FILE P. I. No. 0000762, Lowndes County **OFFICE** Preconstruction
NHS-0000-00(762)
I-75 Improvements from north of SR 133 **DATE** August 17, 2007
to Cook County Line, Phase II

SUBJECT APPROVED REVISED PROJECT CONCEPT REPORT

SUBJECT: **Revised Project Concept Report**

REVISED PROJECT CONCEPT REPORT

TS NO 3
N.T.S.

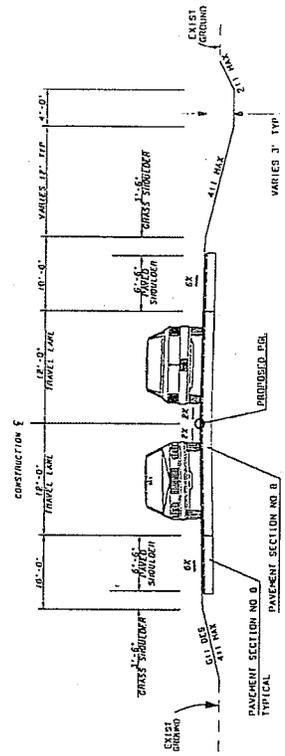
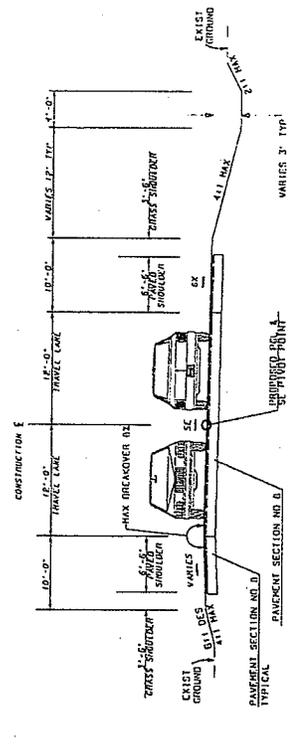
- Retaining Walls versus end rolls used at Bridge Bent No 1 & 3. See Attachment Number 4, Typical Sections drawing no. 5-03.
- Relocated Morven Road intersects SR 122 at minimum 660-foot median opening spacing from versus opposite the proposed I-75 southbound ramps. The existing Morven Road (CR 782) curve is compounded to accommodate the relocated Morven Road tie-in thus eliminating the proposed stop condition.

The SR 122 (Main Street) bridge over I-75 is revised from 74.1 feet wide by 387 feet long with a 4-foot flush median to 91.25 feet wide by 233.67 feet long with a 20-foot raised median. In addition to providing for a fourth 12-foot lane on I-75, the SR 122 bridge spans are lengthened to accommodate an additional 36.33 feet (12-foot outside paved shoulder + 2.33-foot concrete median barrier + 10-foot inside paved shoulder + 12-foot lane) of future I-75 construction in each direction. To minimize impacts to the interchange area the bridge consists of two (2) versus four (4) spans by utilizing retaining walls instead of 2:1 sloped end rolls.
